PRIVATE PLAN CHANGE REQUEST

REZONING OF LAND AT 49, 57 AND 71 MILL ROAD FROM RURAL 3 ZONE TO MAIN RESIDENTIAL ZONE

Amendments to:

MANUKAU OPERATIVE DISTRICT PLAN 2002

(1.4) Add Figure 13.4 as follows:

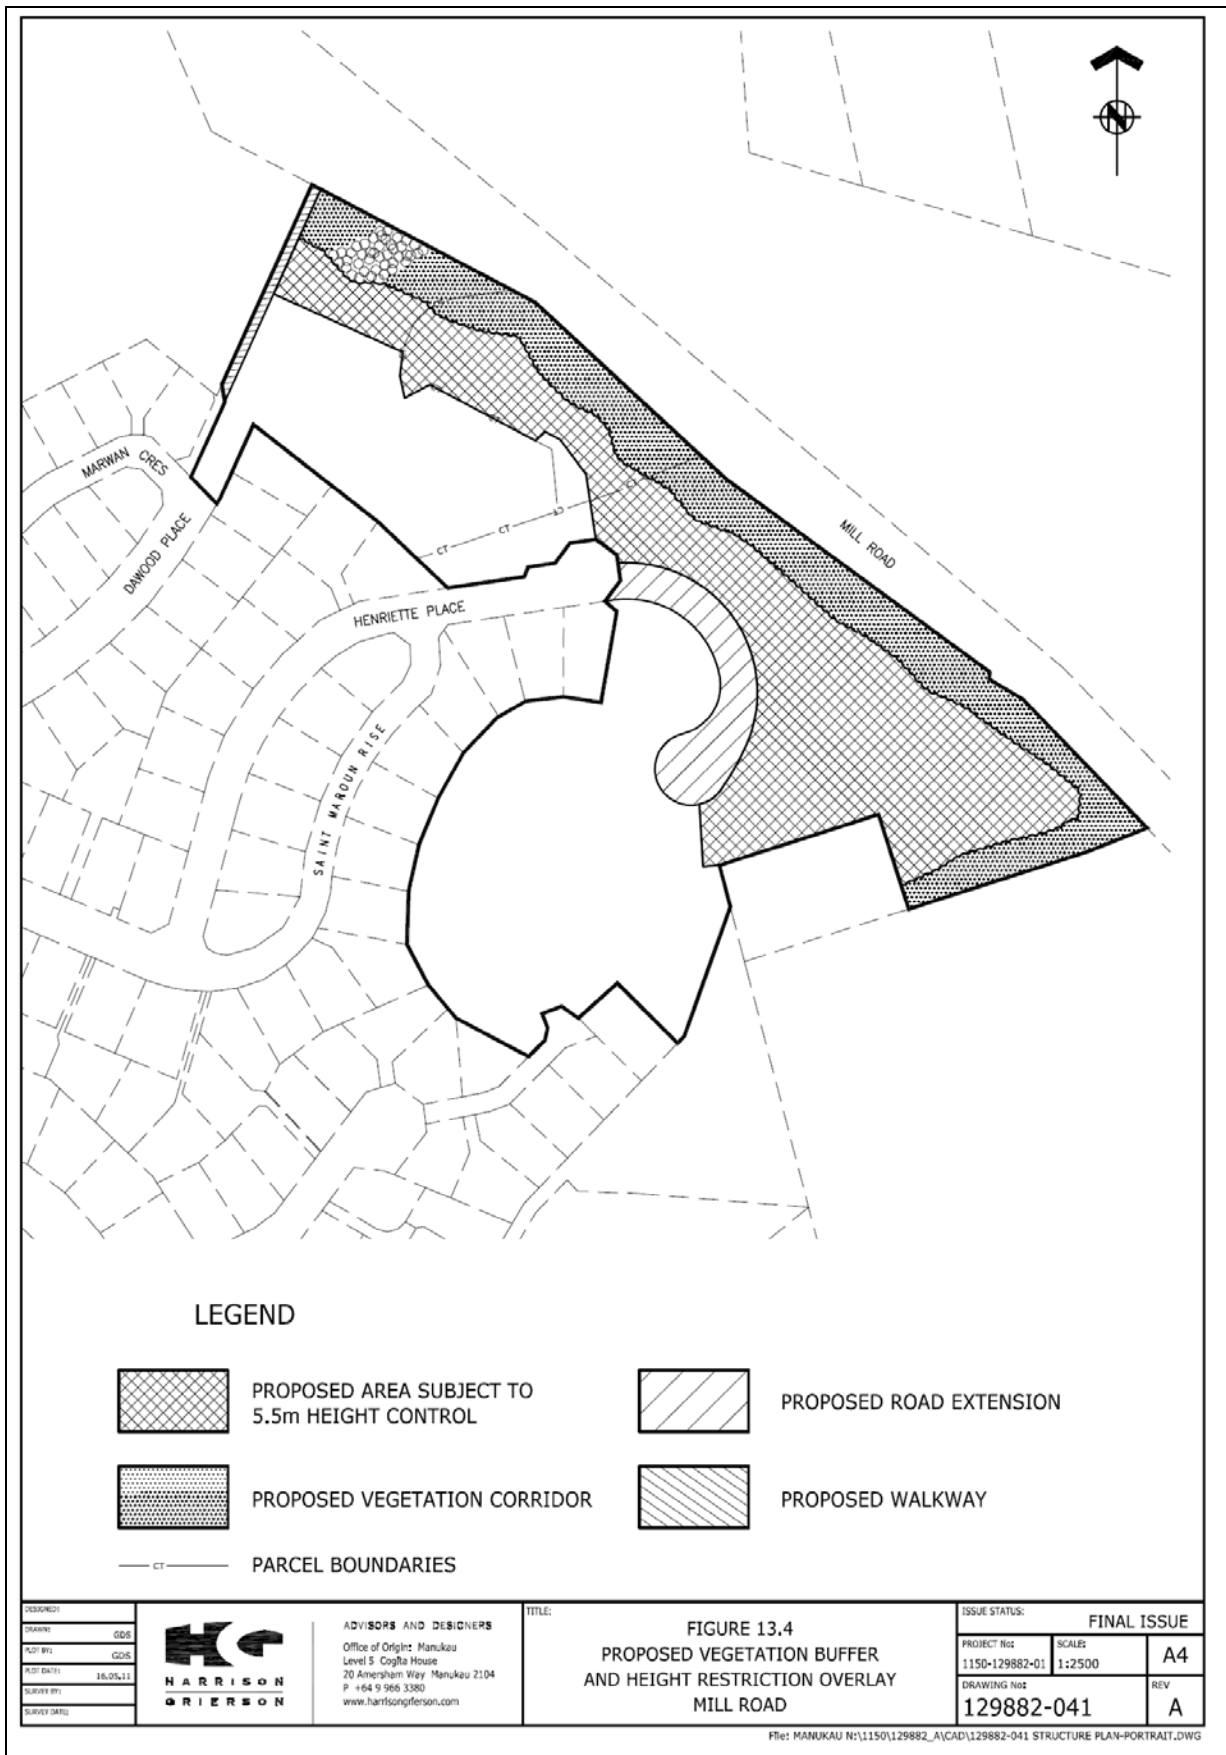
13.11.1.9.9 Buildings located in the “Sensitive Ridge or Coastal Margin” Area as delineated on the Planning Maps and relating to Lot 101 DP 402310(CT 410531), Lot 1 DP 153098 (CT 91B/719), LOT 100 DP 400896 & 1/9 SHARE LOT 66 DP 356203 (CT 453011)

In addition to all other requirements of the Plan, any building located in the “Sensitive Ridge or Coastal Margin” Area delineated on the Planning Maps relating to Lot 101 DP 402310(CT 410531), Lot 1 DP 153098 (CT 91B/719), LOT 100 DP 400896 & 1/9 SHARE LOT 66 DP 356203 (CT 453011) shall comply with the vegetation buffer area and 5.5m maximum height area as shown on Figure 13.4 and shall be assessed as a Controlled Activity pursuant to Rule 13.12.7.

For the avoidance of doubt, any building not complying with the vegetation buffer area and 5.5m maximum height area as shown on Figure 13.4 shall be a non-complying activity.

(2.2) Amend Figure 16.15 as follows:

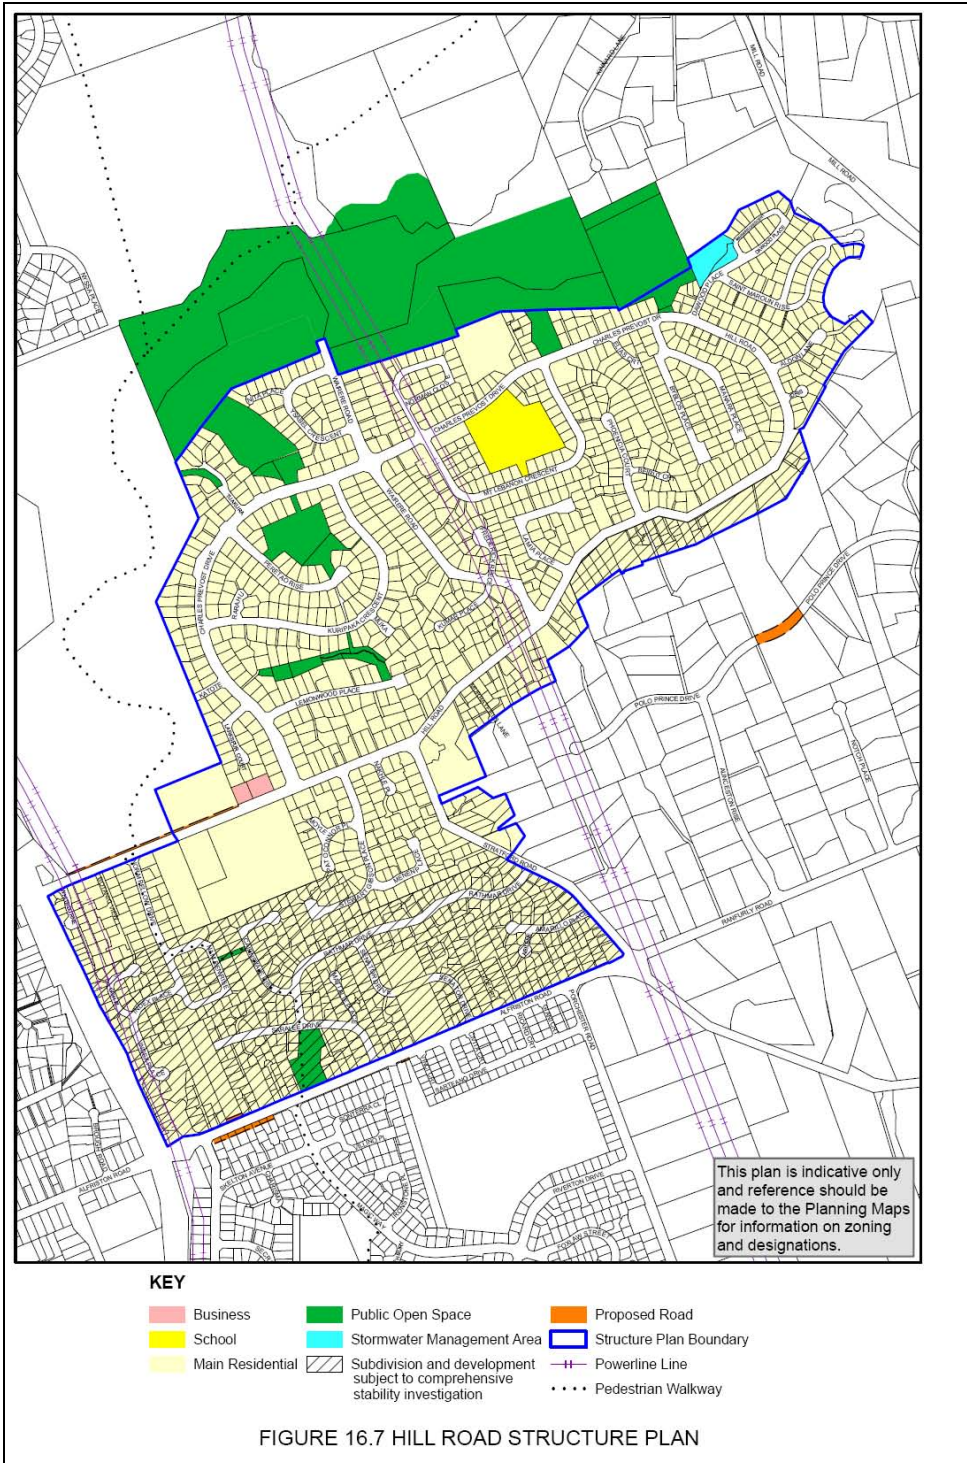
In order to protect the visual amenity of the rural / urban interface in the vicinity of Mill Road, the planting of a landscape buffer and the retention of existing vegetation along the portion of that interface depicted on Figure 16.7-13.4 should be a condition of subdivision consent.

(3.1) Amend Maps 42 & 52 as follows:

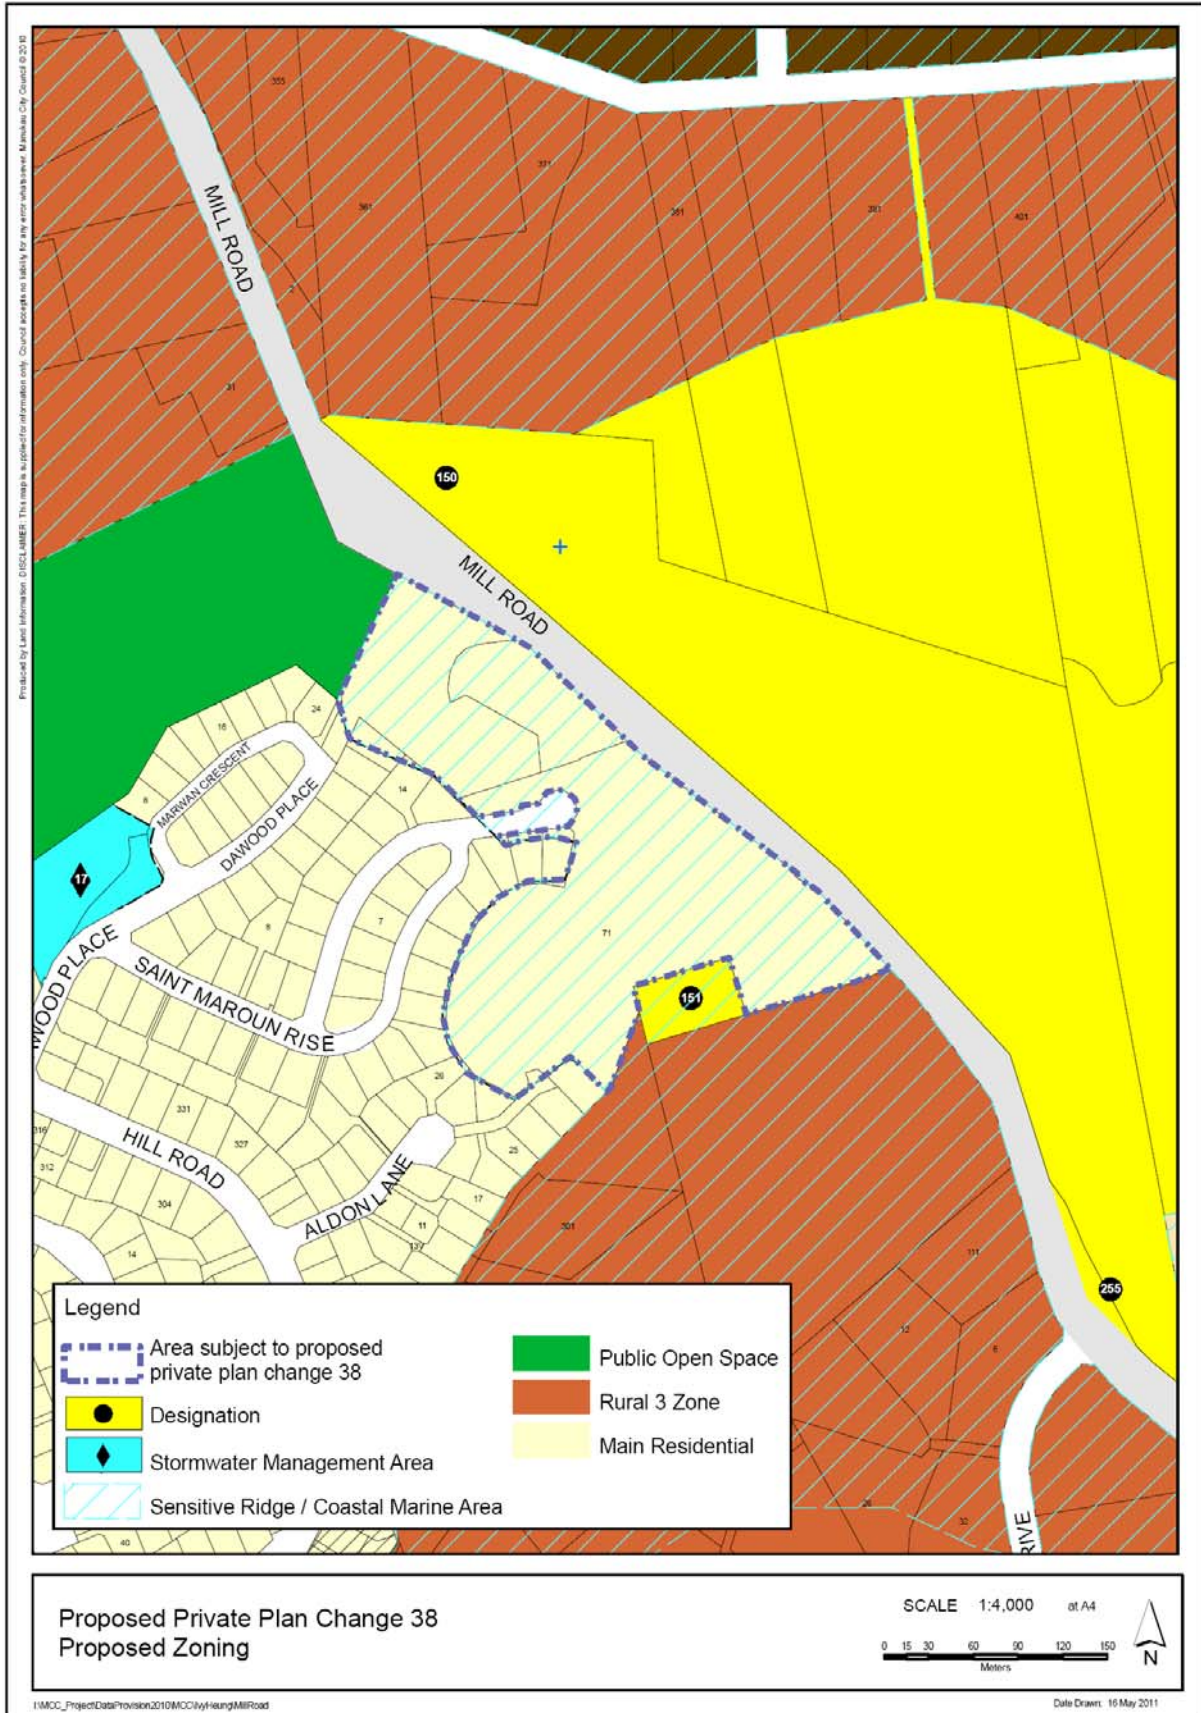
1. Map 42
2. Map 52
